Exhibit 3.3

Hodges Creek Matrix of Required Retrofits to Covered Unit Interiors

HODGES CREEK APARTMENTS: COVERED UNIT INTERIORS

D. INACCESSIBLE FEATURES IN COVERED DWELLING UNITS Unit Types by Building:

Unit Plan. (A03/01).

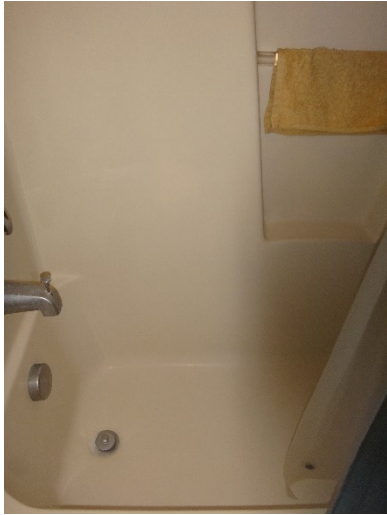
Numbers	Photos	Deficiency	Required Retrofit
19		Extent of blocking in bathrooms cannot be determined without destructive testing.	Provide affidavits to confirm that reinforcement is installed to comply with Requirement 6.
20	 <i>Bathtub/shower surround in Unit 2051-102.</i>	The shape of the bathtub surrounds precludes the installation of future grab bars with firm attachment to blocking (ability to install grab bars required).	Remediate upon resident request.

Numbers	Photos	Deficiency	Required Retrofit
21	 <i>Clear floor space obstructed by adjacent refrigerator and range in Unit 2051-102.</i> 	The outlets above kitchen countertops in 2 areas (both sides of the range) lack the required clear floor space for approach (at least 1 outlet in each counter area must have clear floor space for approach).	Subject to tolerances contained in the agreed-upon remediation protocols, modify existing outlet or install a GFI-rated, molded, multi-plug outlet with commercial grade components to bring outlet into compliance with Requirement #5. Any such outlet must be approved by the United States prior to installation.

Numbers	Photos	Deficiency	Required Retrofit
	 <i>Measurement of clear floor space width.</i>		
22	 <i>Placement of tape between refrigerator and dishwasher in Unit 2051-102.</i>	The clearance between kitchen elements (face of refrigerator to face of dishwasher) is 38-3/4 inches (minimum 40 inches required).	Remediate upon resident request.

Numbers	Photos	Deficiency	Required Retrofit
	 <i>Measurement of clearance.</i>		
23	 <i>Dimension from side wall to centerline of lavatory in Unit 2051-102.</i>	The lavatory centerlines are 18-1/2 inches to the side wall (minimum 24 inches required) and the cabinets are not removable.	Install removable base cabinet to provide clear floor space to comply with Requirement 7(2)(a)(ii).

Unit Plan. (A03/02).

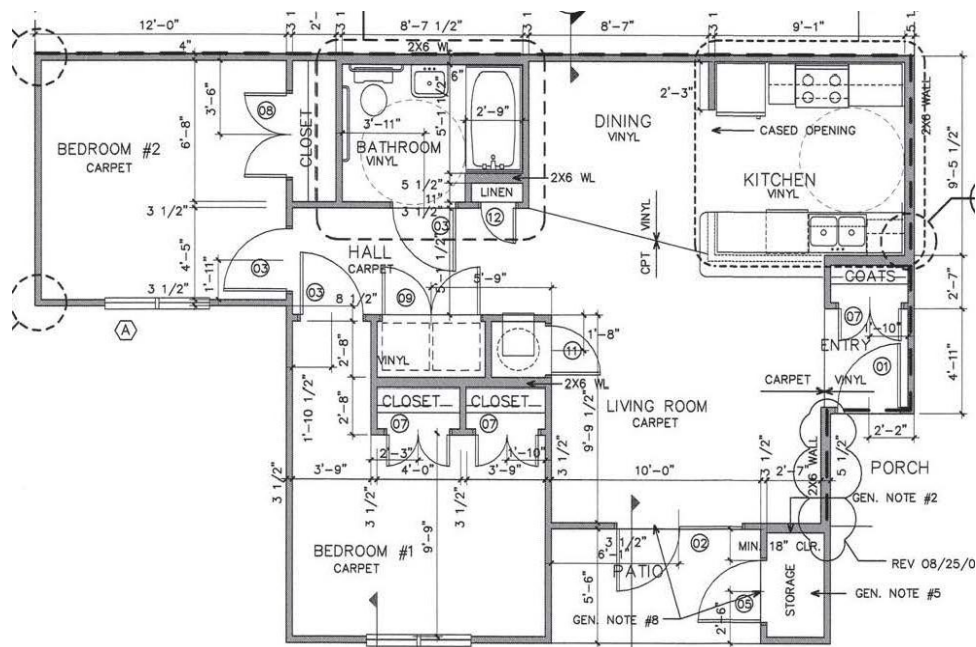
Numbers	Photos	Deficiency	Required Retrofit				
24	 <i>Entrance door threshold interior side in Unit 2010- 104.</i>	Door thresholds are 5/8 inch high at the interior face and are not beveled (maximum 1/4 inch without bevel allowed).	Modify door thresholds to comply with Requirement 4(4).				
25	 <i>Thermostat in Unit 2010-105.</i>	The thermostat top controls are more than 48 inches above the floor (maximum 48 inches allowed). <table><thead><tr><th><u>Location</u></th><th><u>Height (inches)</u></th></tr></thead><tbody><tr><td>Unit 2010-105</td><td>50-1/8</td></tr></tbody></table>	<u>Location</u>	<u>Height (inches)</u>	Unit 2010-105	50-1/8	Accept proposed fix. Modify thermostat at 50 1/2" to comply with Requirement 5.
<u>Location</u>	<u>Height (inches)</u>						
Unit 2010-105	50-1/8

Numbers	Photos	Deficiency	Required Retrofit
26	 <i>Clear floor space obstructed by adjacent refrigerator and range in Unit 2010-104</i>  <i>Measurement of clear floor space width.</i>  <i>Projection of range beyond</i>	The outlet above one area of kitchen countertop lacks the required clear floor space for approach (at least 1 outlet in each counter area must have clear floor space for approach). Both the refrigerator and range are greater than 25 inches deep.	Subject to tolerances contained in the agreed-upon remediation protocols, modify existing outlet or install a GFI-rated, molded, multi-plug outlet with commercial grade components to bring outlet into compliance with Requirement #5. Any such outlet must be approved by the United States prior to installation.

Numbers	Photos	Deficiency	Required Retrofit						
	countertop.								
27	 <i>Pedestal sink in Unit 2010- 104.</i>  <i>Measurement from bathtub to lavatory centerline in Unit 2010-104.</i>	The lavatory centerlines are less than 24 inches to the side wall (minimum 24 inches required) and knee space is not provided.

Location	Distance (inches)	Unit 2010-104 bathroom	19-1/2	Unit 2051-103 bathroom	18 +/-	Install removable base cabinet to provide clear floor space to comply with Requirement 7(2)(a)(ii).
Location	Distance (inches)								
Unit 2010-104 bathroom	19-1/2								
Unit 2051-103 bathroom	18 +/-

Unit Plan. (A03/03).

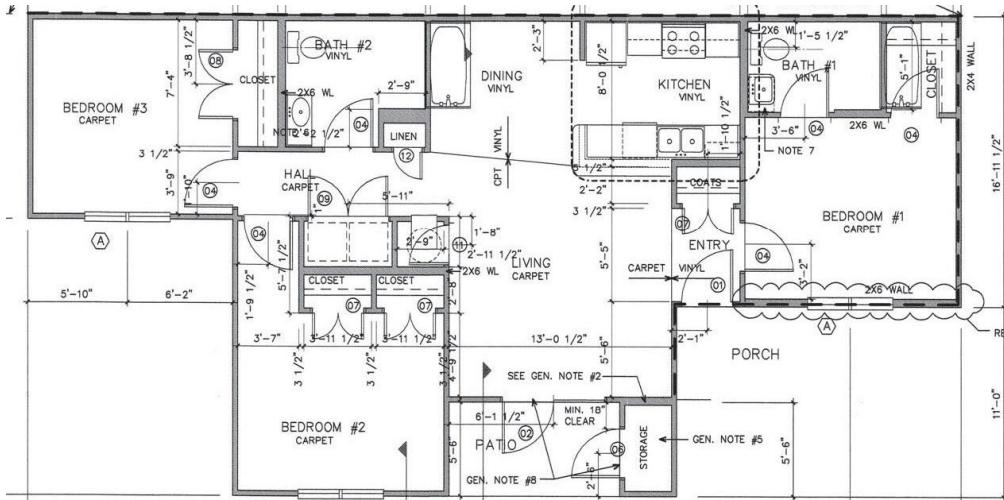
Numbers	Photos	Deficiency	Required Retrofit
28	 <i>Entrance door threshold interior side at Unit 2020- 101.</i>	Door thresholds are 1/2 inches high at the interior face and are not beveled (maximum 1/4 inch without bevel allowed).	Modify door thresholds to comply with Requirement 4(4).
29	 <i>Measurement of storage room threshold at Unit 2020- 101.</i>	Door thresholds are 3/4 inch high and are not beveled (maximum 1/4 inch without bevel allowed).	Modify door thresholds to comply with Requirement 4(4).

Numbers	Photos	Deficiency	Required Retrofit
30	 <i>Thermostat in Unit 2020-101.</i>	The thermostat top controls are 61 inches above the floor (maximum 48 inches allowed).	Modify thermostat to comply with Requirement 5.
31		Extent of blocking in bathrooms cannot be determined without destructive testing.	Provide affidavits to confirm that reinforcement is installed to comply with Requirement 6.

Numbers	Photos	Deficiency	Required Retrofit
32	 <i>Bathtub/shower surround in Unit 2020-101 hall bathroom.</i>	The shape of the bathtub surrounds precludes the installation of future grab bars with firm attachment to blocking (ability to install grab bars required).	Remediate upon resident request.
33	 <i>Clear floor space obstructed by adjacent refrigerator and range in Unit 2020-101.</i>	The outlets above kitchen countertops in 2 areas (both sides of the range) lack the required clear floor space for approach (at least 1 outlet in each counter area must have clear floor space for approach).	Subject to tolerances contained in the agreed-upon remediation protocols, modify existing outlet or install a GFI-rated, molded, multi-plug outlet with commercial grade components to bring outlet into compliance with Requirement #5.

Numbers	Photos	Deficiency	Required Retrofit
	 <i>Clear floor space obstructed by range in Unit 2020-101.</i>  <i>Measurement of clear floor space width.</i>		
34	 <i>Placement of tape between refrigerator and countertop in Unit 2020-101.</i>	The clearances between the refrigerator to the opposing countertop are 38-3/4 inches (minimum 40 inches required).	Remediate upon resident request.

Numbers	Photos	Deficiency	Required Retrofit
35	 <i>Lavatory in Unit 2020-101 hall bathroom.</i>  <i>Measurement from side wall to lavatory centerline.</i>	The lavatory centerlines are less than 24 inches to the side wall (minimum 24 inches required) and the cabinets are not removable.	Install removable base cabinet to provide clear floor space to comply with Requirement 7(2)(a)(ii).
